UNITED STATES  
NUCLEAR REGULATORY COMMISSION  
WASHINGTON, D. C. 20555

ENCLOSURE 2

SAFETY EVALUATION OF THE REQUEST TO OPERATE  
THE SHOREHAM NUCLEAR POWER STATION AT 25% POWER  
ACCIDENT EVALUATION

Figure 1 Accident signatures for the MSIV-closure ATWS from 100% power operation, first 45 minutes with no operator action

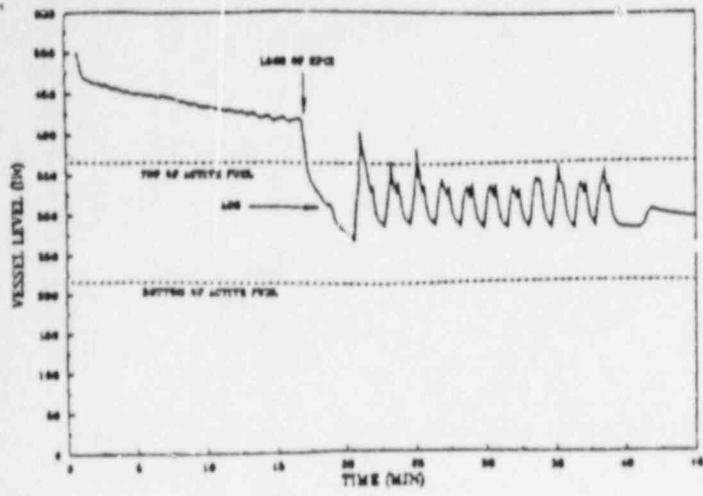
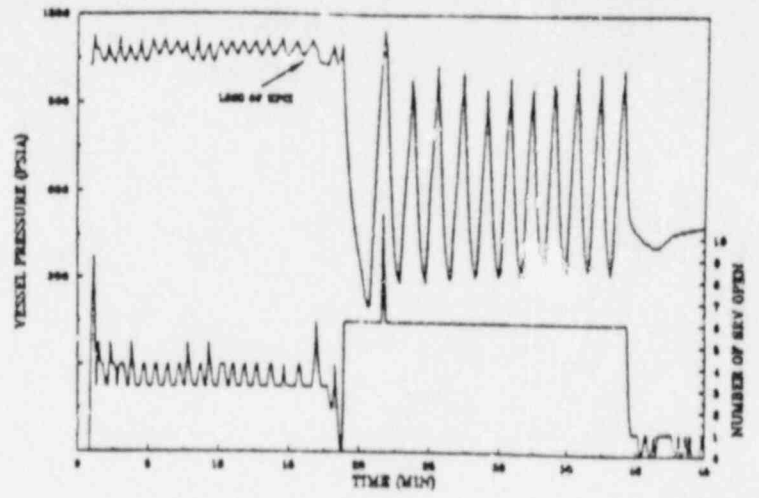
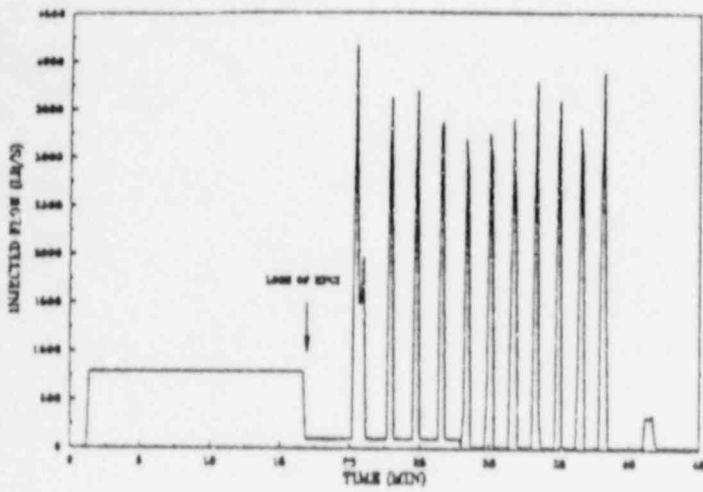
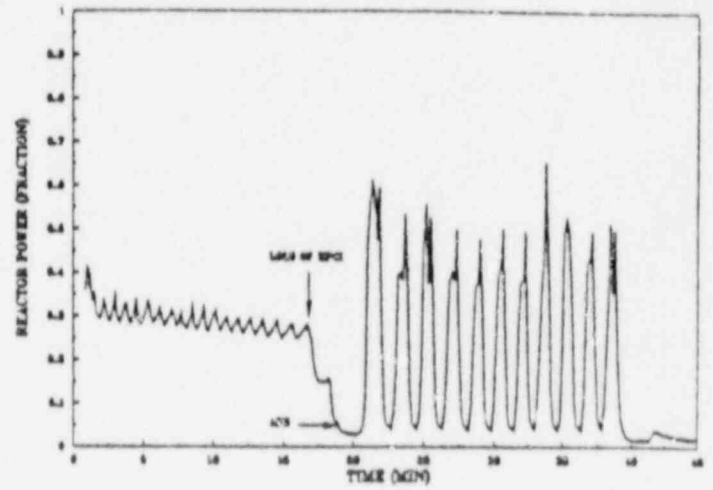
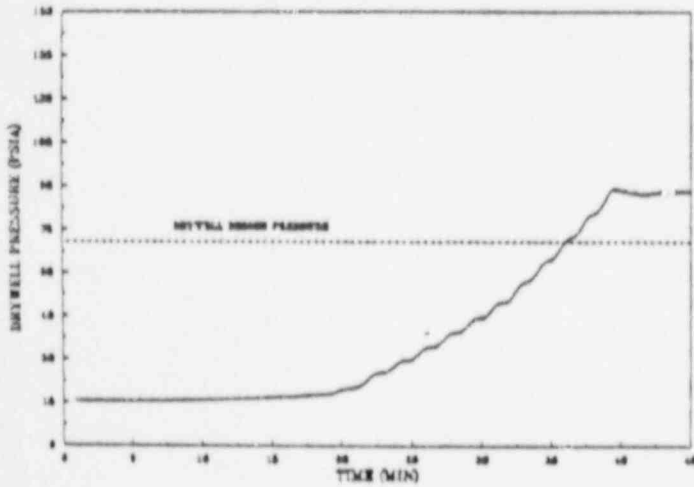
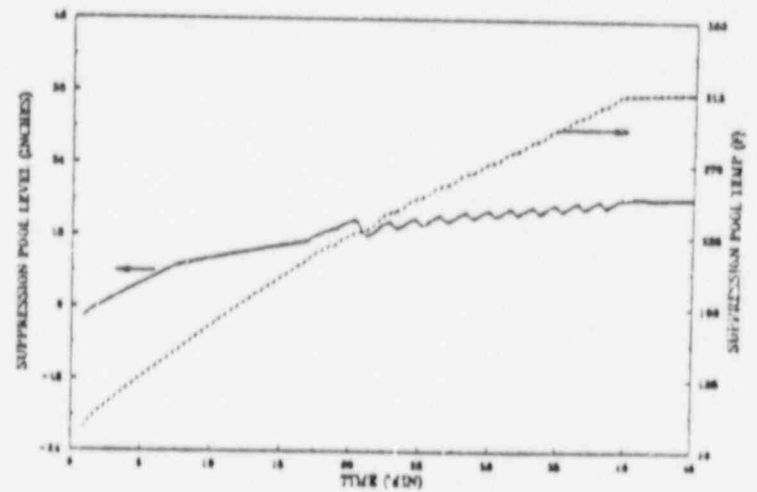
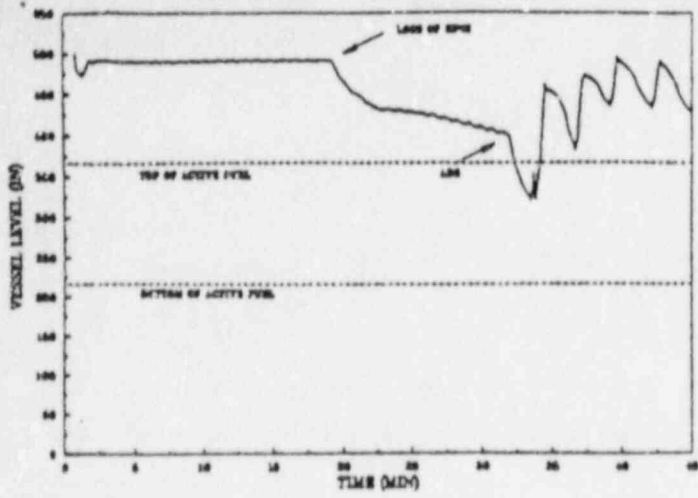
The calculated results for the two cases are shown in Figures 1 and 2. In the analyses, HPCI, RCIC, and CRD injection maintain reactor vessel water level above the top of core until failure (by assumption) of the HPCI turbine at a suppression pool temperature of 210°F. With HPCI system failure, reactor vessel water level decreases, leading to ADS actuation. As the vessel is depressurized into the regime in which the low pressure injection systems are able to pump cold water into the vessel, oscillations in injection flow, core power, and vessel pressure occur as a result of positive reactivity insertion associated with collapse of voids in the core by cold water. Similar trends are observed in both cases but the following key differences should be noted:

1. The time to ADS actuation and core uncover is significantly later for 25 percent power,
2. The frequency and magnitude of pressure and power oscillations is reduced for 25 percent power, and
3. Drywell pressure remains below the design value for 25 percent power but exceeds it for 100 percent power.

Much of these differences in behavior can be attributed to the fact that the negative reactivity of the core voids relative to that of the control blades is less with the control blades in their 25 percent power configuration. It follows that perturbations that tend to collapse voids in the core region will insert less positive reactivity with the control blades in their 25 percent power positions than with the control blades in their 100 percent power positions. Hence, the core response to positive reactivity insertions caused by uncontrolled cold water injection by the low pressure ECC systems is more sluggish at 25 percent power.

On the basis of these calculations, the staff concludes that adequate mitigation of an ATWS accident sequence, given failure of complete shutdown, is much simpler for the control room operators if the control blades are in their configuration for 25 percent power operation as opposed to their configuration at 100 percent power. While we expect the likelihood of ATWS events to be extremely low at Shoreham due to hardware improvements and mitigative capabilities at 25 percent power, should an ATWS occur the safety concerns at 25 percent power would be substantially less than at full power.

Figure 3 CRAC2 calculated dose-versus-distance probability distributions for whole body dose of 5 rem -- wetwell venting scenario

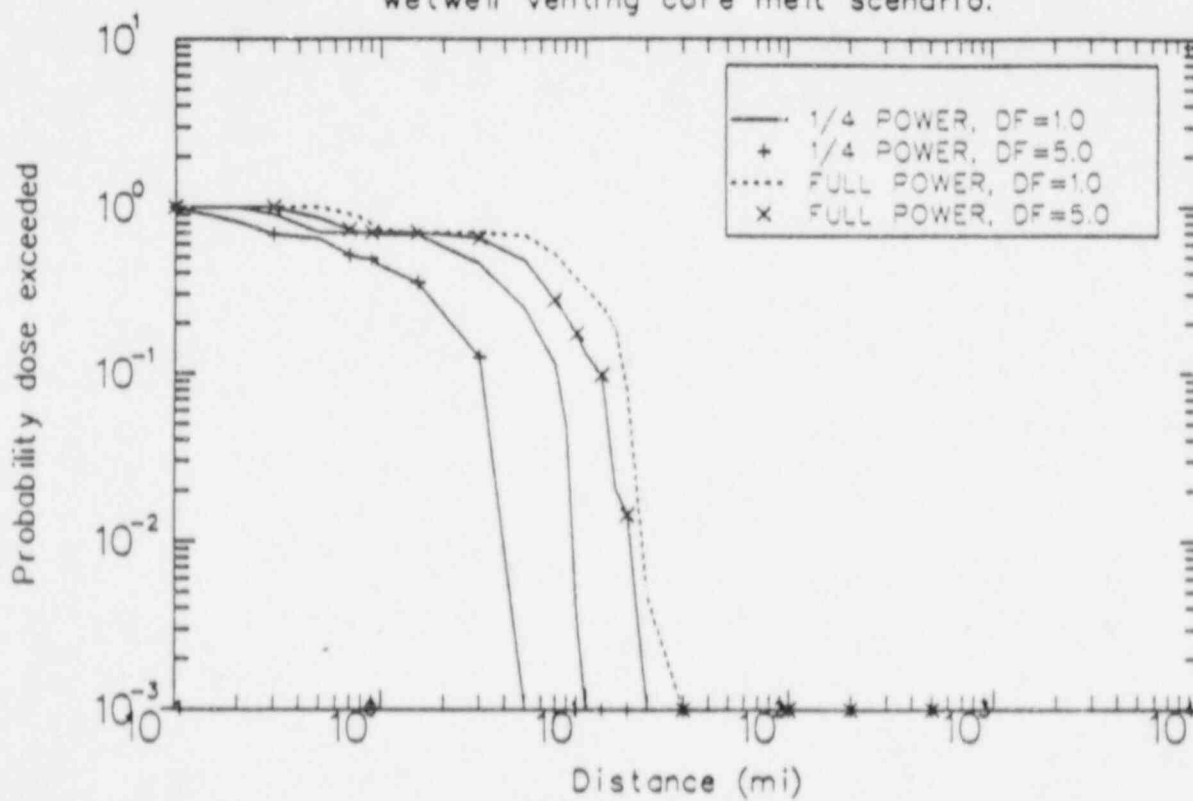
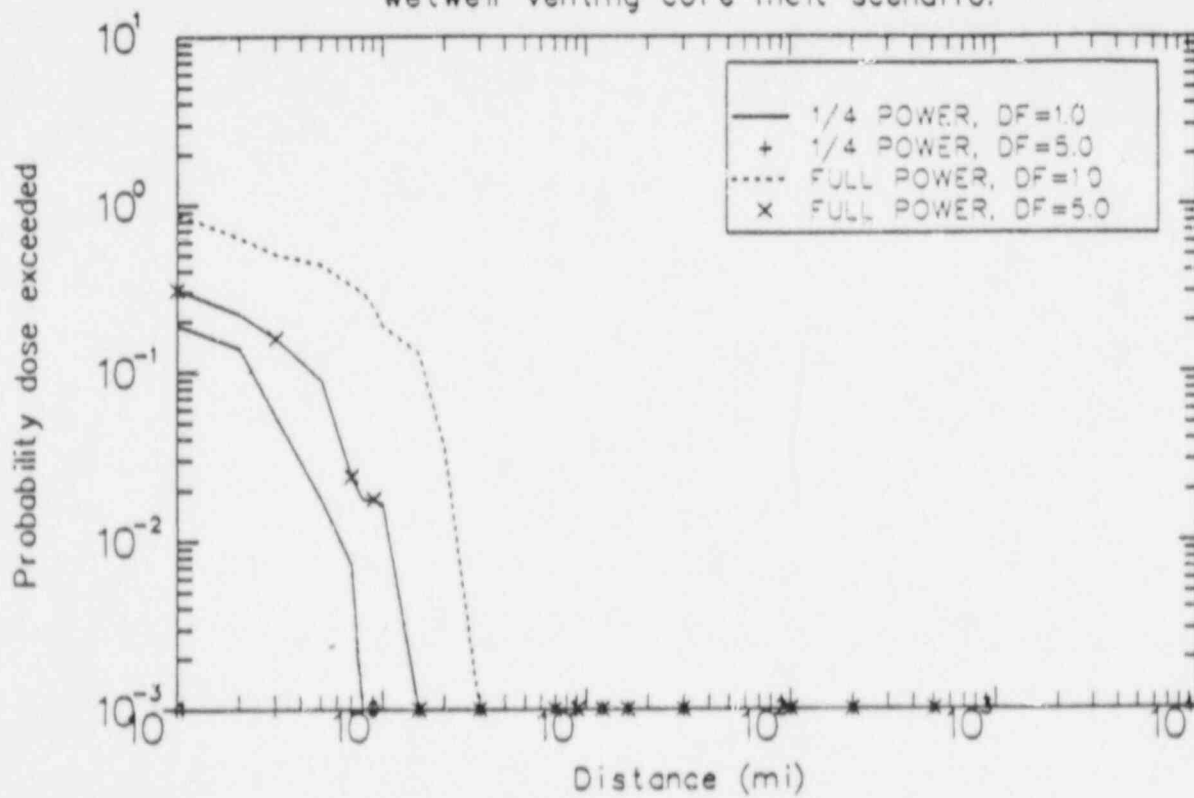
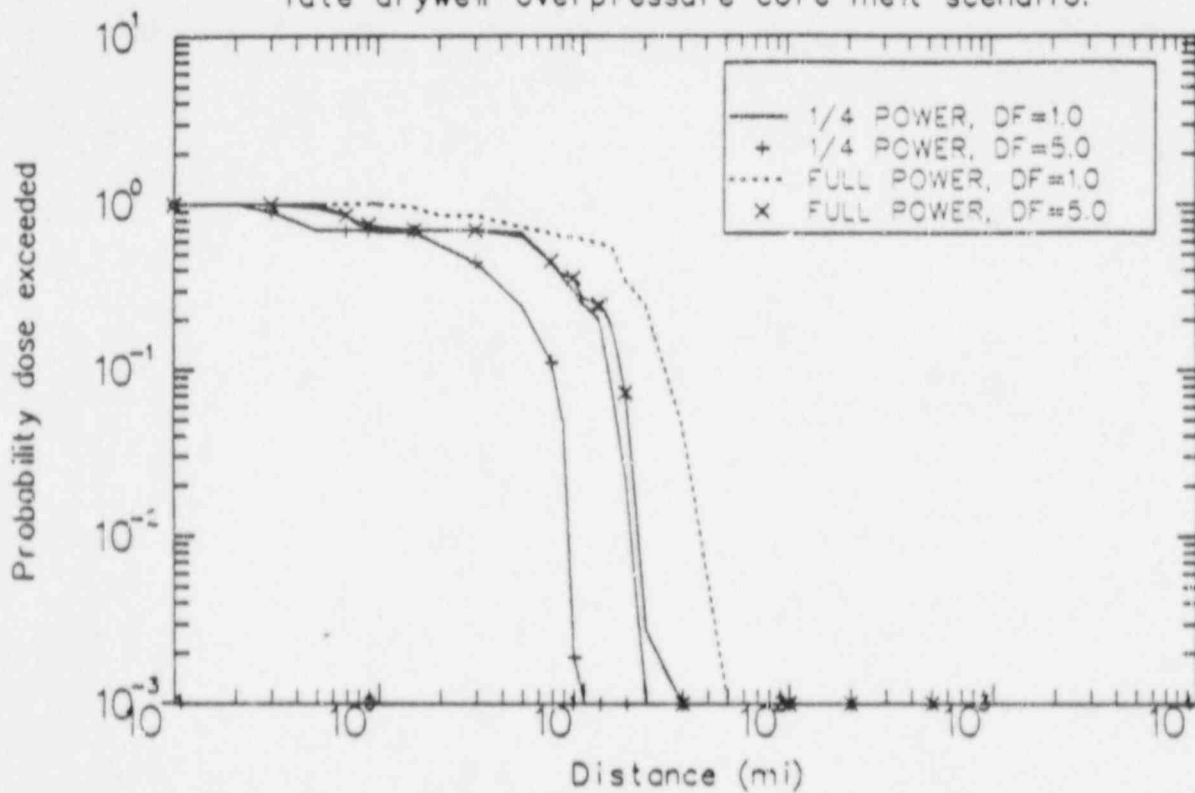
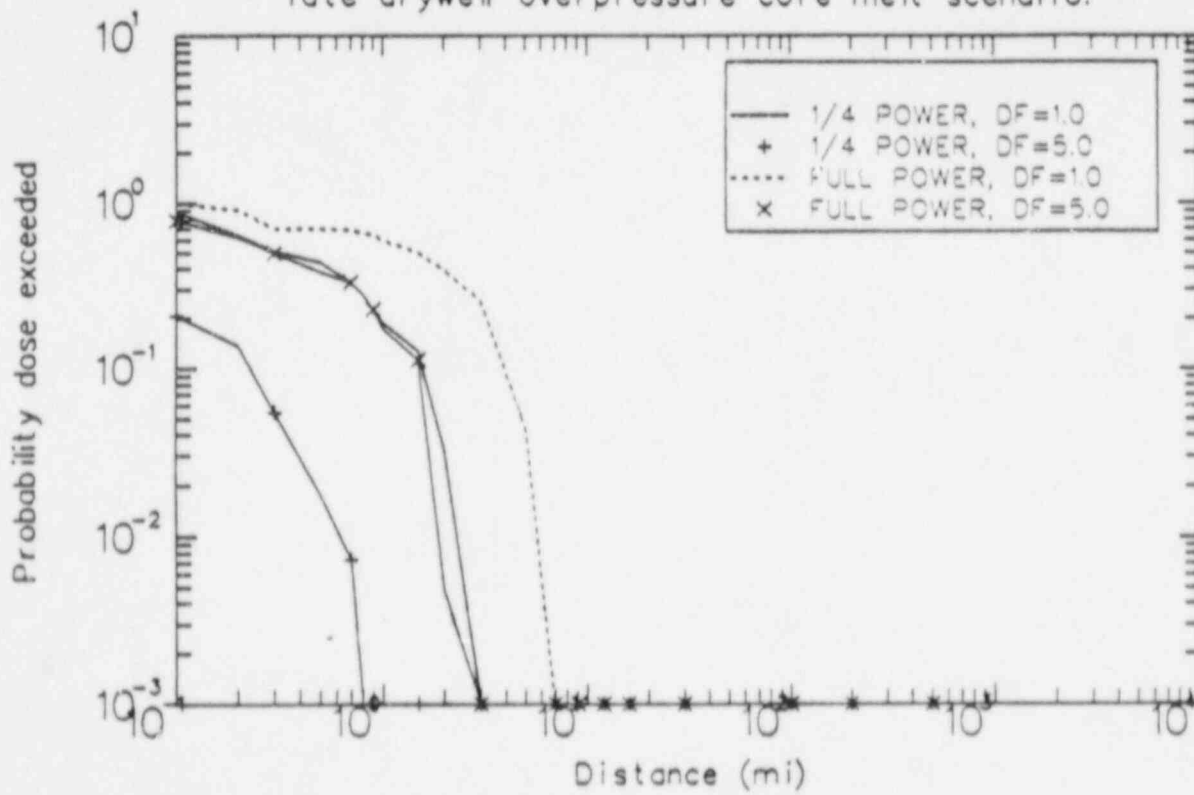
Figures 3 and 4 show the five rem and 200 rem whole-body dose-versus-distance results for the core melt scenario with wetwell venting. Similar results are shown in Figures 5 and 6 for the scenario with drywell overpressure failure. Unlike the final results presented in the utility submittal (as well as the curves presented in NUREG-0396), the probabilities shown for each scenario are conditional upon that scenario occurring. In contrast, the LILCO leakage categories were weighted by the release category probability given a core melt and the results were summed over all release categories.

The dose-versus-distance curves provide insights regarding the distances from the reactor over which either the Protective Action Guides (PAGs) might be exceeded or injury-threatening doses might occur in the more likely core melt sequences. However, because of the limited nature of this assessment and the large uncertainties inherent in estimation of source terms and modelling of offsite consequences, these results should be interpreted in a qualitative manner, i.e., they should not be used to estimate reduced distances over which protective measures may need to be taken in the event of an accident. Suffice it to say that the distance over which a given dose is exceeded would be significantly reduced at 25 percent power (by a factor of about three relative to full power) but that estimation of the absolute distances at which major reductions occur in the probability of dose exceedance would require a further assessment of uncertainties.

Figure 7 CRAC2 calculated probability of 5 rem whole body dose being exceeded at 2 miles from the plant -- wetwell venting scenario

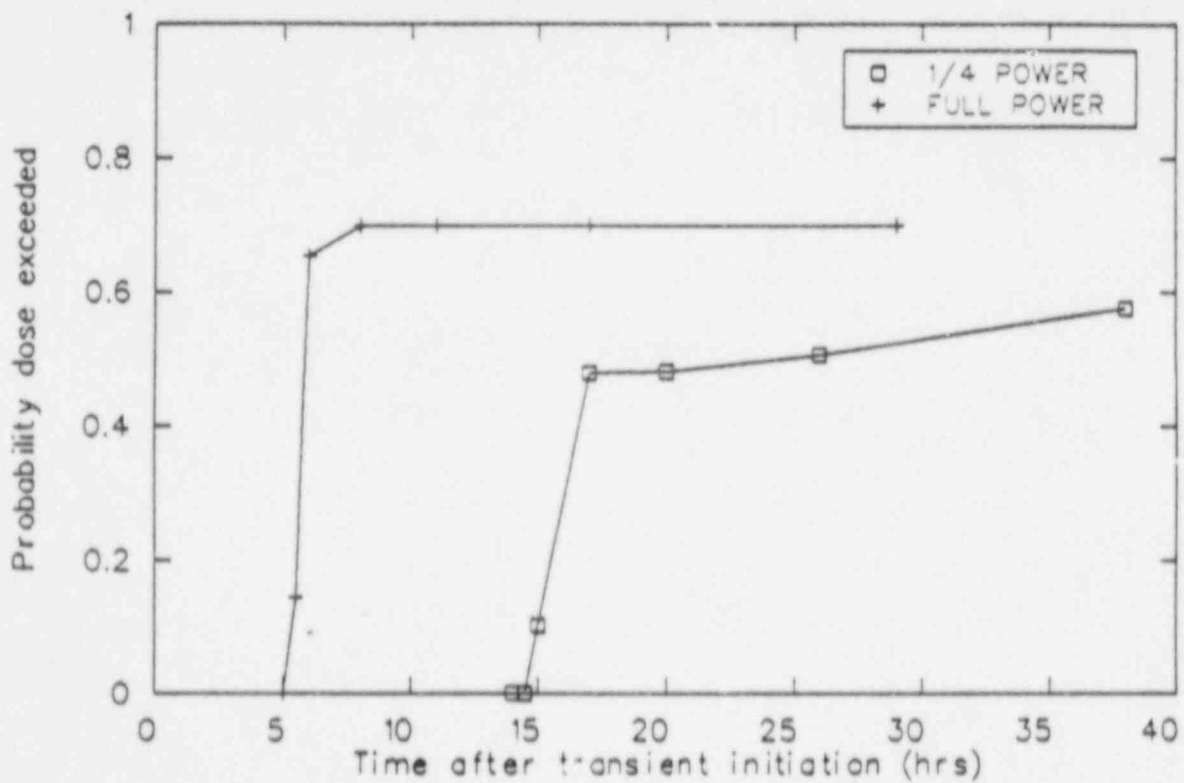
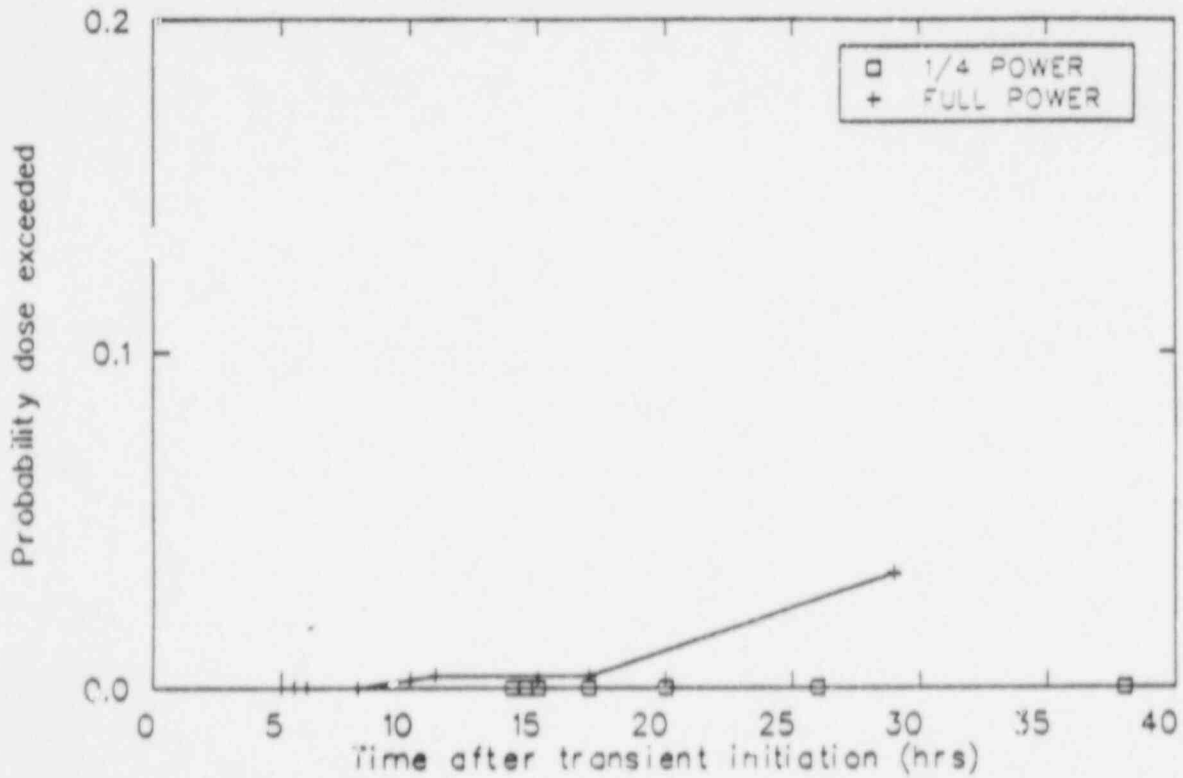
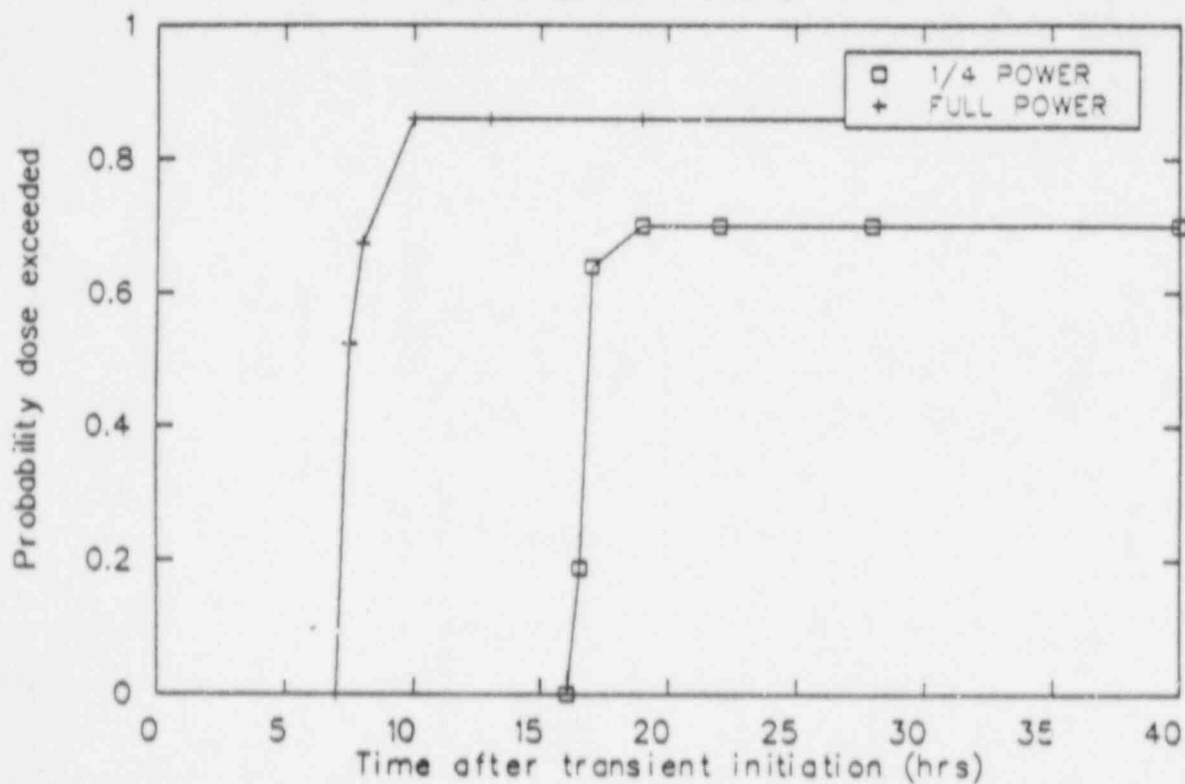
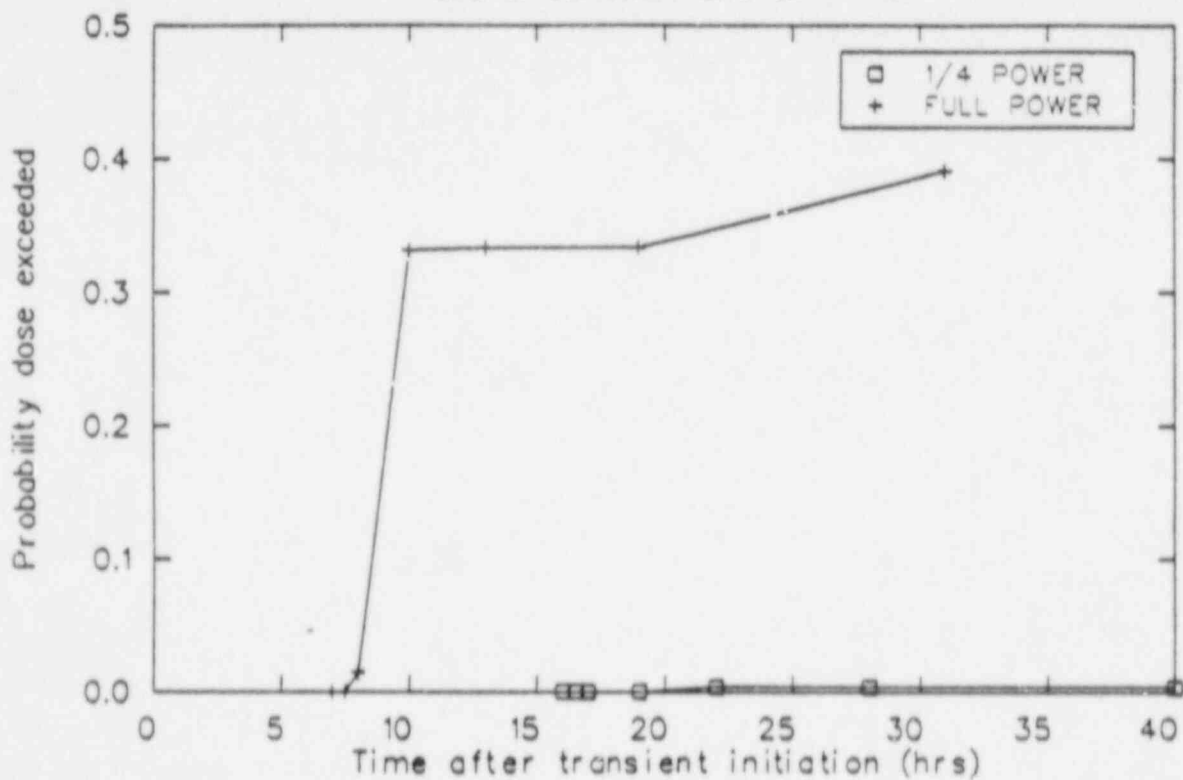
To provide some perspective as to the additional time for protective actions afforded by operation at 25 percent power, dose-versus-time probability figures were also generated. Figures 7 and 8 show the probability of five rem and 200 rem whole-body doses being exceeded at two miles versus time for the wetwell venting scenario at 25 percent and 100 percent power. Results for the scenario
